Historical Consultant Report on Structural Floor Penetrations

Prepared by Keast & Hood Company

State of Maryland Department of General Services HVAC and Interior Piping Renovations Maryland State House

5.03 Penetrations below fan coil units

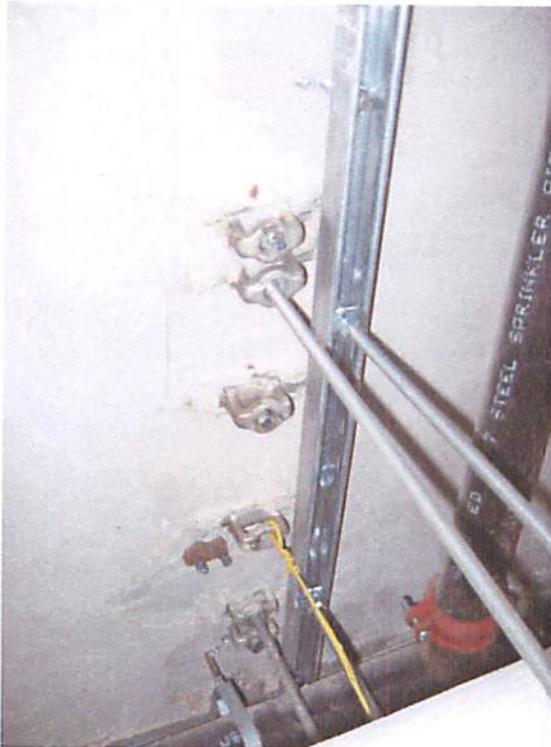
Damage to tile deck typical below fan coil units

Another typical location of structural damage to the tile decks is the holes that were historically cut to feed the fan coil units installed around the perimeter of the first and ground floors. These holes have been reused, although perhaps enlarged and/or altered, during the current renovations. It is unfortunate that alternative locations for vertical distribution of utilities could not be found during the design phase. Fortunately, it is not too late to repair the damage caused by the mechanical penetrations. Subsequent to our 2000 report, in which we recommended removing the tile entirely from beam to beam at large penetrations, we have had success retrofitting damaged tile decks with shotcrete. This is, however, a very messy operation.

Recommendation: Repair tile decks below fan coil units.

5.04 Hanging HVAC and Plumbing Hardware Directly from Ceiling Tiles:

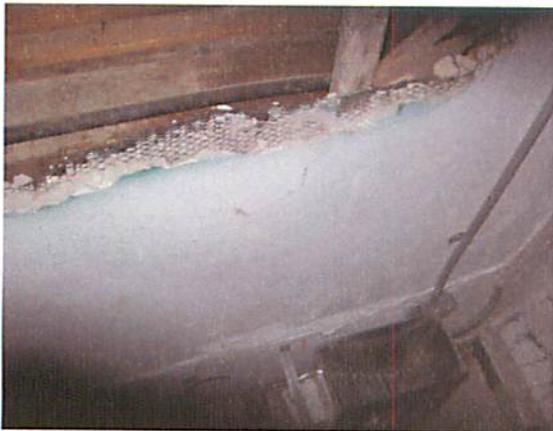
While this photograph actually depicts an appropriate historic ceiling hanger (left row of hangers) attached directly to a beam flange above, there are many locations in the basement ceiling where mechanical equipment is not supported from a beam, hanging directly from the ceiling tiles instead (right row of fasteners). Historic structural systems, such as the terra cotta tile arch system, are brittle and weakened by installing fasteners directly into the tile.

Recommendation: All attachments should have been directly hung from the bottom flanges of steel beams. K&H Co. recommends that the steel anchor manufacturers be required to perform pull-out tests to qualify the existing installations.

5.06 Diffuser Grill Notched into Floor Joist:

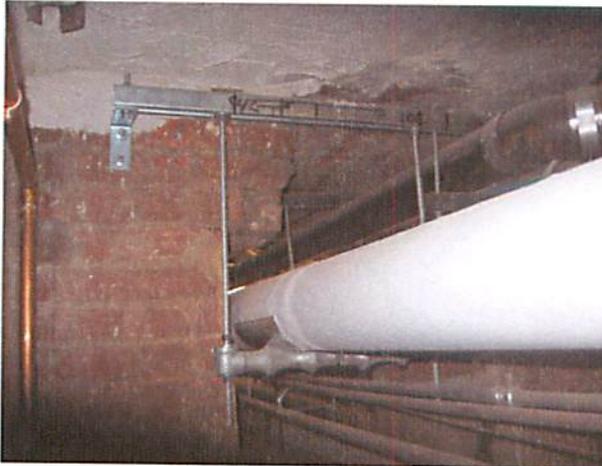
Here, ductwork cuts into the original wooden floor joists. Such intrusive additions weaken joist live load capacities.

Recommendation: Mechanical system work should avoid joist penetrations, unless the penetrations are compensated for with remedial structural details.

5.09 Cracked Walls:

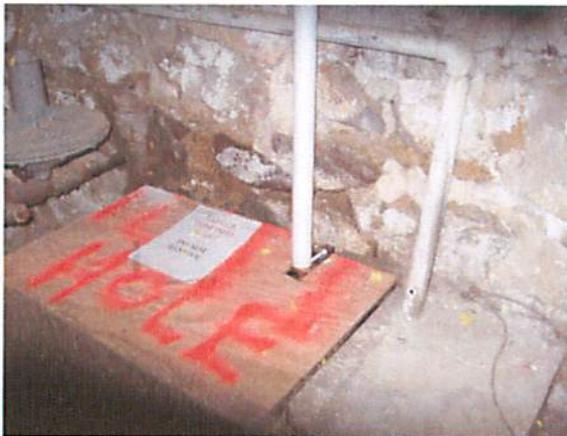
As a direct result of the lack of foundation shaft underpinning, additional building settlement and separation has occurred. Significant cracks were observed in both the interior and exterior walls of the Old Senate Chamber on the second floor, as well as the second floor wall bordering on the brick-vaulted room. The cracked wall areas correspond with the locations of the undermined foundations shown in 5.08b and 5.10.

Recommendation: Fill cracks in these walls and address moisture intrusion issues before replastering in Old Senate Chamber occurs; concurrently, address underpinning needs of foundation walls.
